POINT BEACH NUCLEAR PLANT UNIT NO. 2

AMENDMENT TO FACILITY OPERATING LICENSE

Amendment No. 29
License No. DPR-27

SUPPORTING AMENDMENT NO. 29 TO LICENSE DPR-27

FIGURE 15.3.10-3

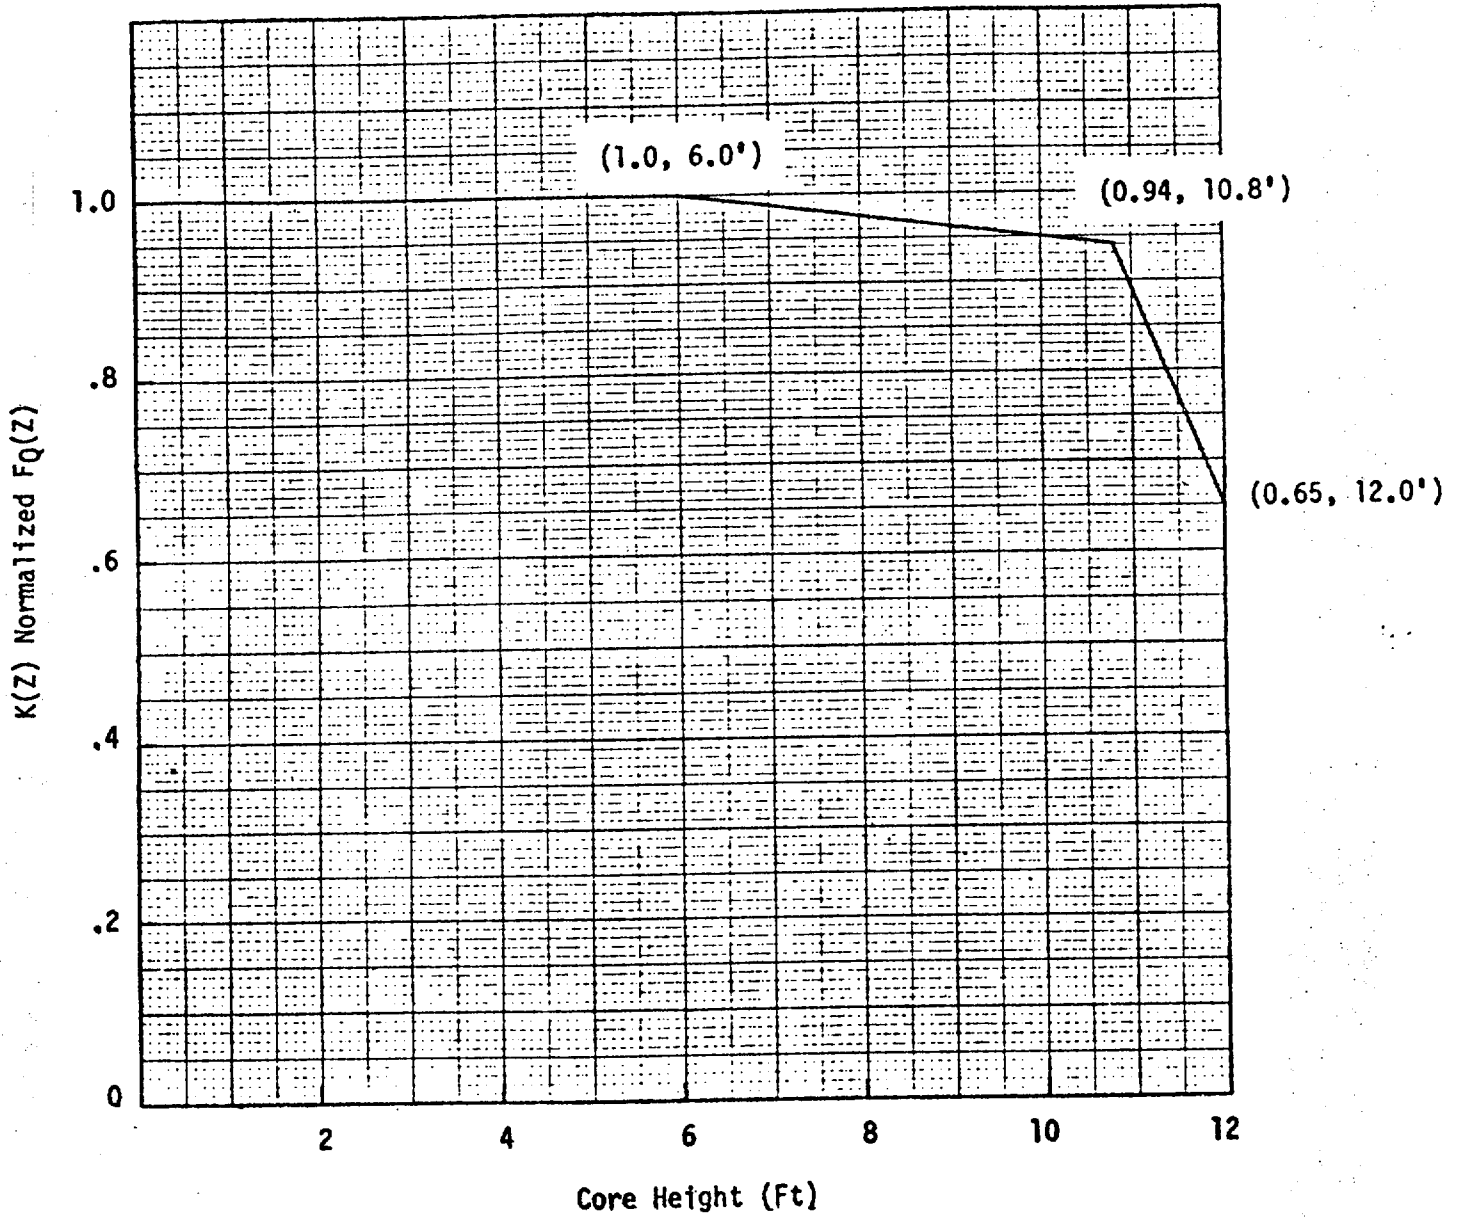
The existing Hot Channel Factor Normalized Operating Envelope (Figure 15.3.10-3) applies to core Cycle 3. For core Cycle 4 the licensee has proposed a modification to the 10.8 to 12 foot core elevation line segment that results in a lower limit curve. The remainder of the envelope remains unchanged. This proposed change will provide an additional margin of safety; and thus, is acceptable.

where P is the fraction of full power at which the core is operating, K(Z) is the function in Figure 15.3.10-3 and Z is the core height location of F_Q .
